**REQUEST FOR TENDER
ORANGUTAN OUTDOOR EXHIBIT CONSTRUCTION
RFT#: TZC T 57-2019-12
ADDENDUM # 2**

Date Issued: 2020 January 15
Project Name: **Toronto Zoo Orangutan Outdoor Exhibits**
To: Ben Knoop
Toronto Zoo
361A Old Finch Avenue
Toronto, ON M1B 5K7
Project Number: 18-1-086
RFT Reference No.: TZC T-57-2019-12 (issued 2019-12-17)

ADD #A002

5
S-832 1:10

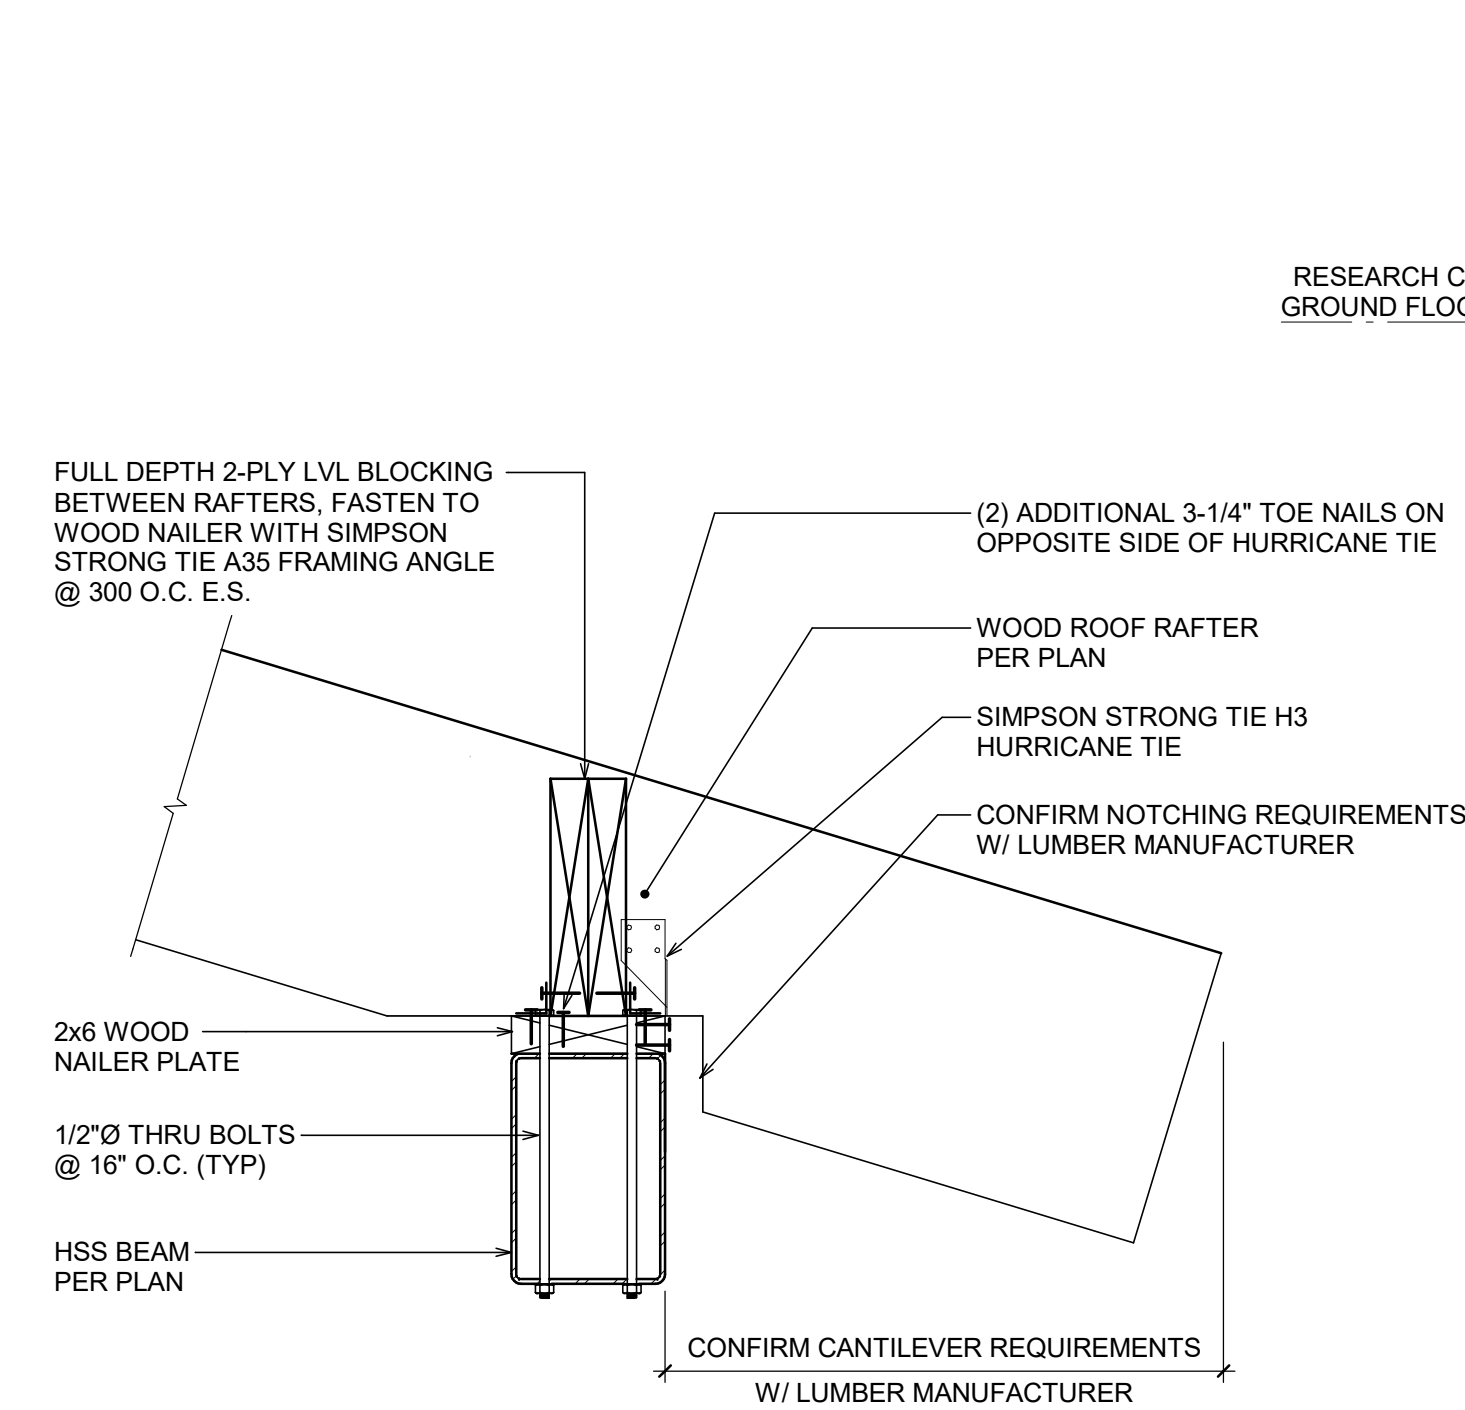
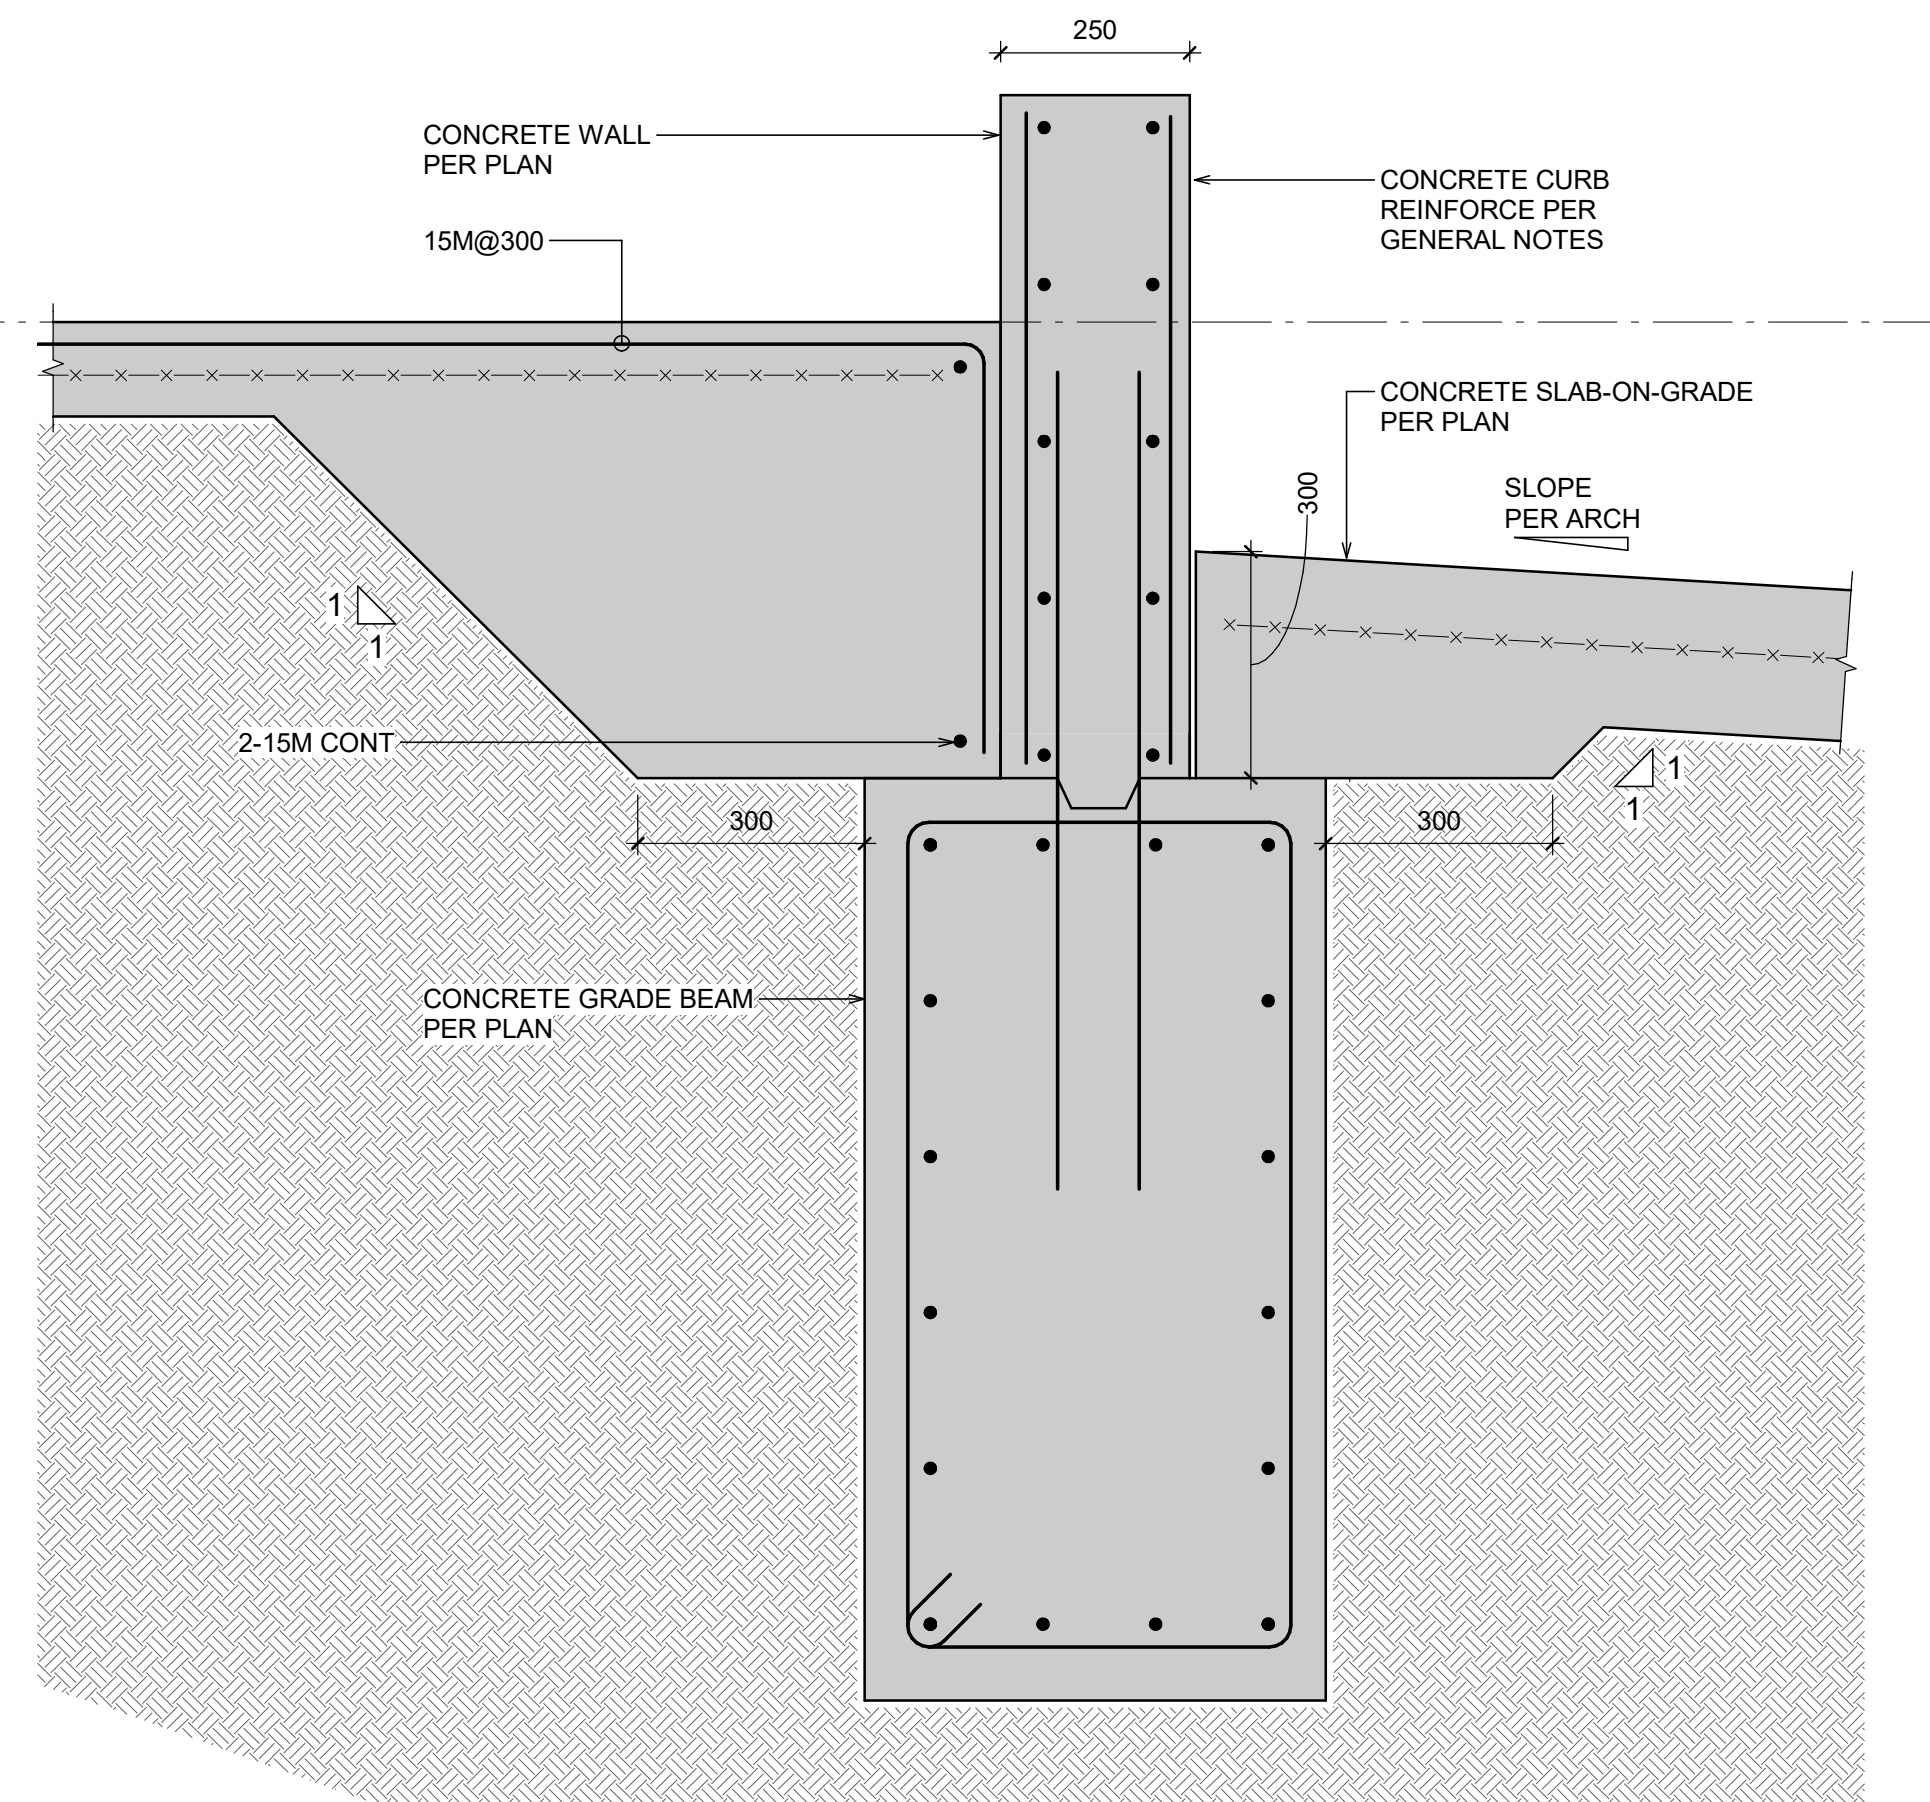
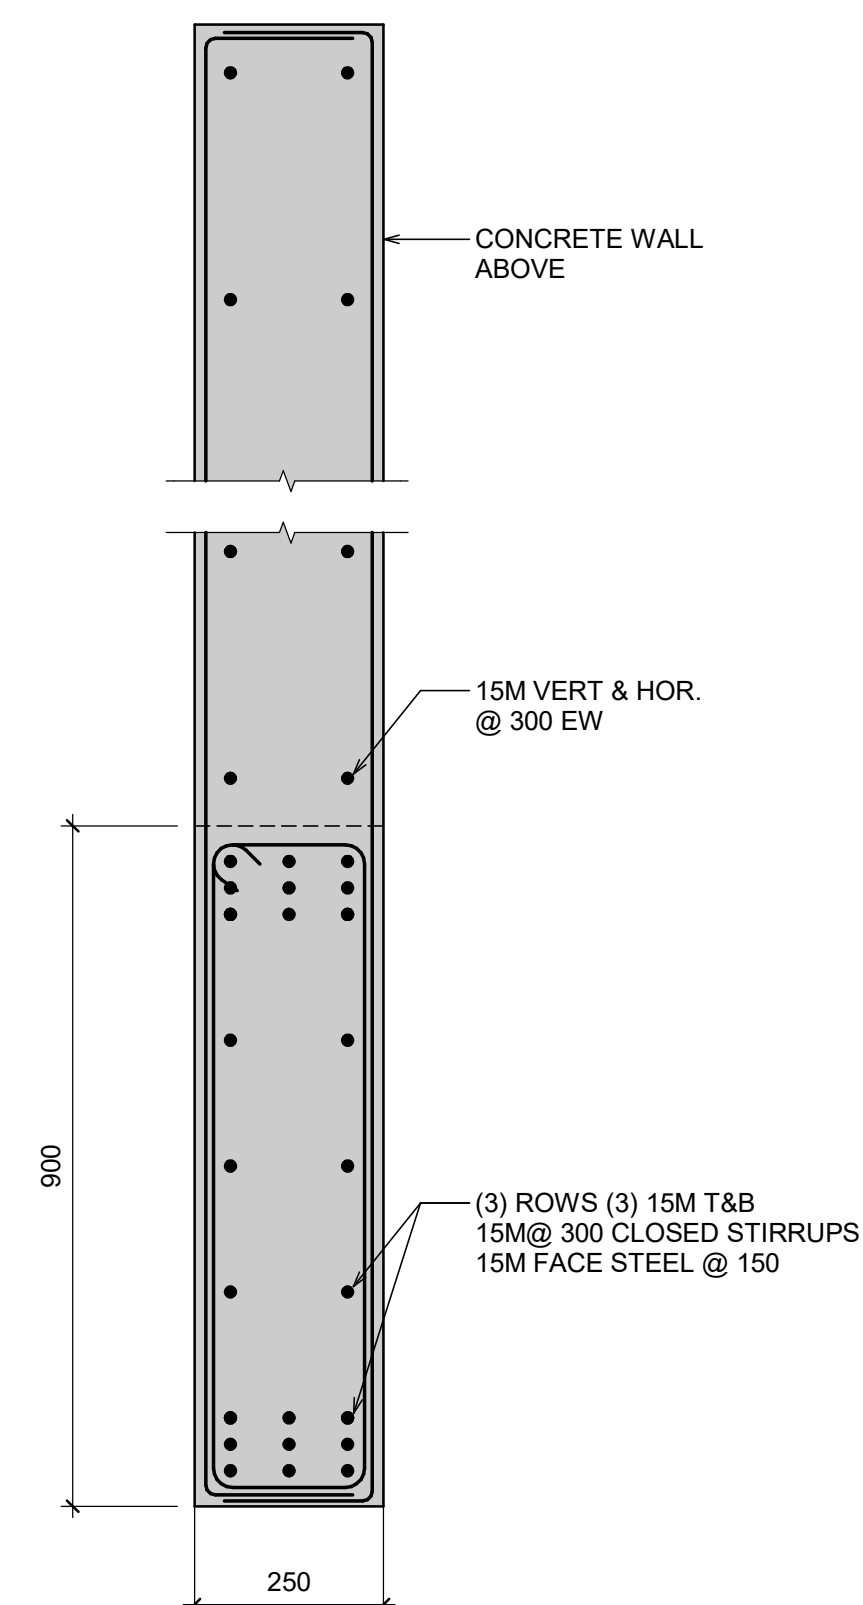
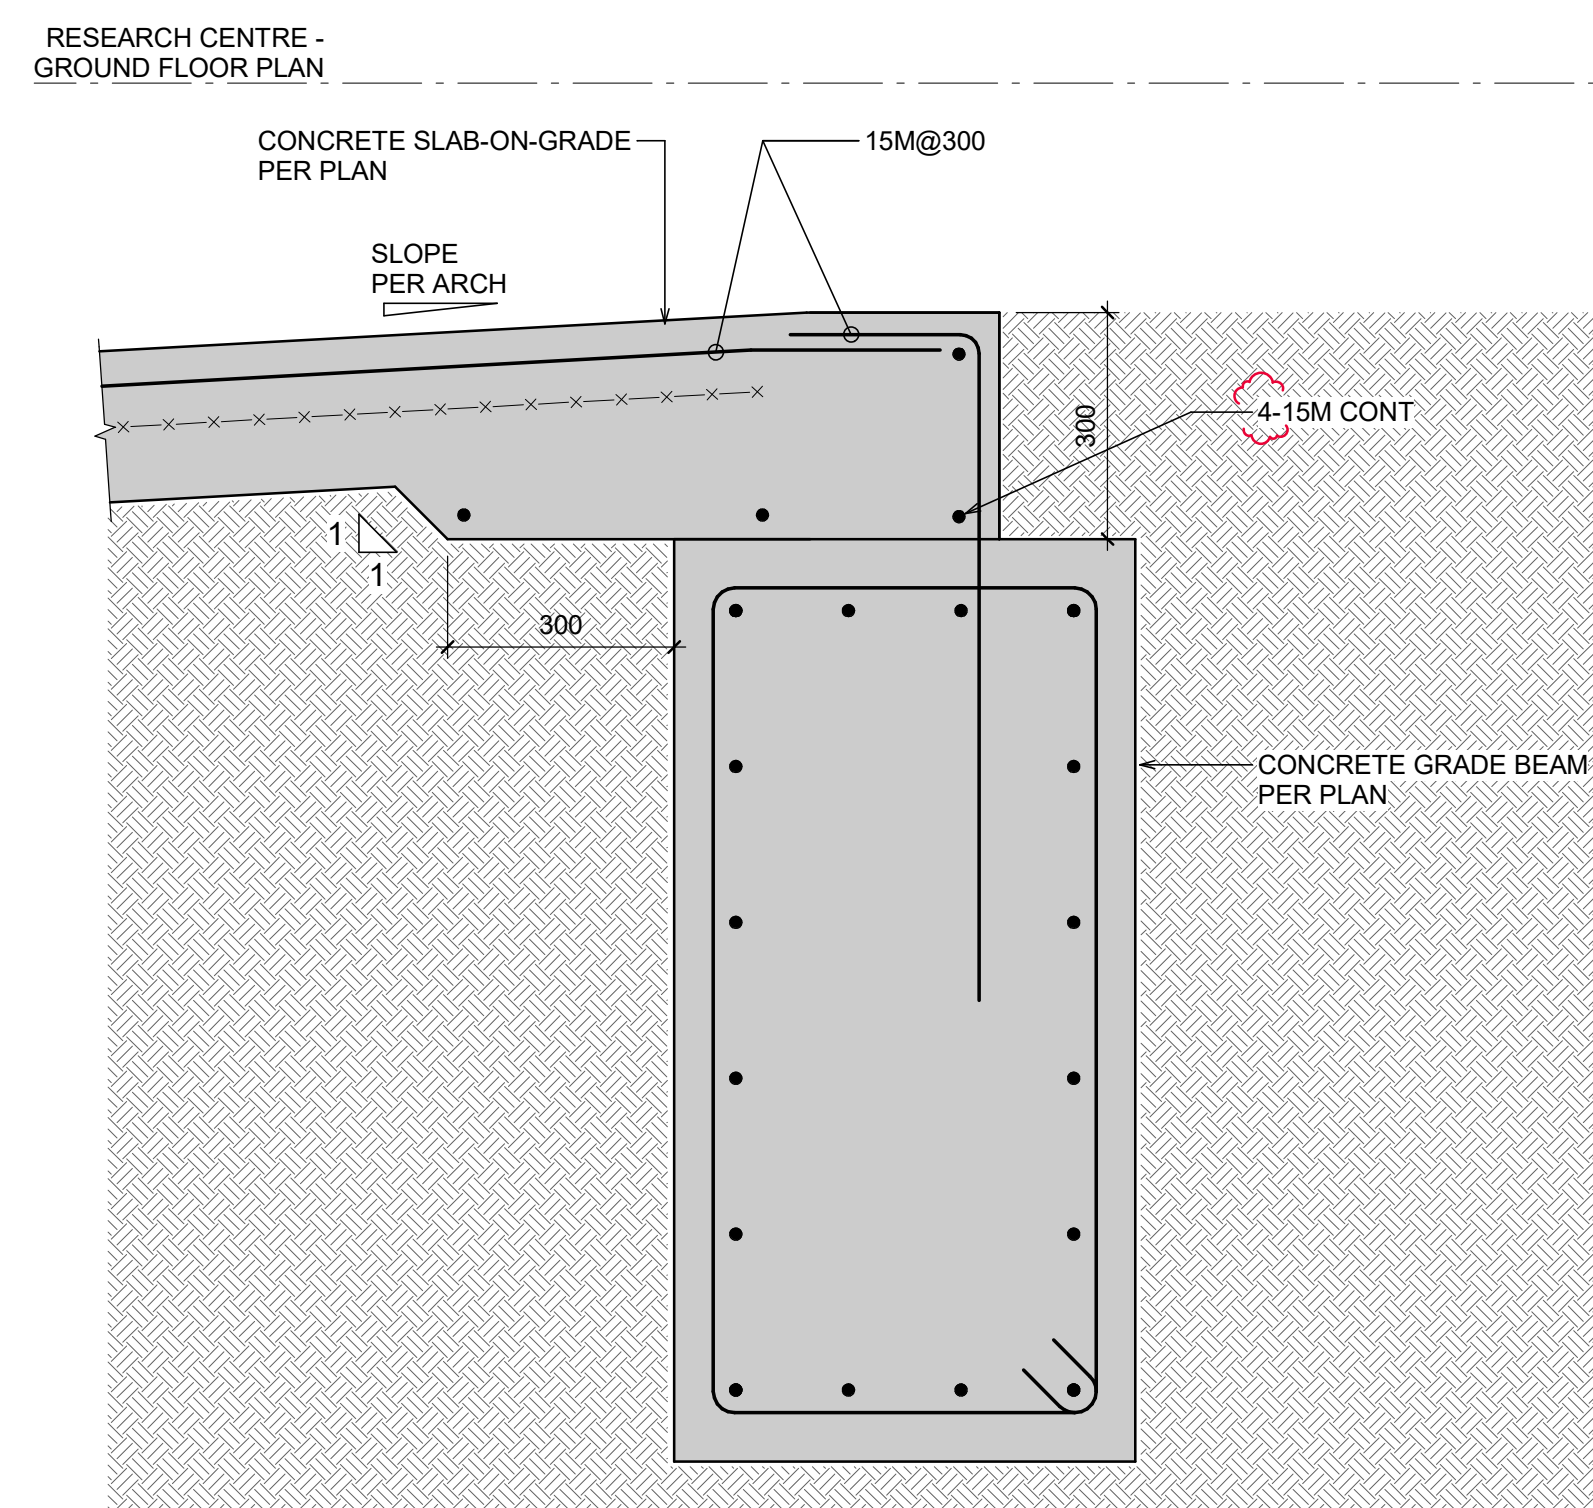
- 4.20. S-832
 - a. Detail 5 modified
- 4.21. S-840
 - a. Braced frame connection forces modified
- 4.22. S-841
 - a. Slab thickened detail added for climbing pipes
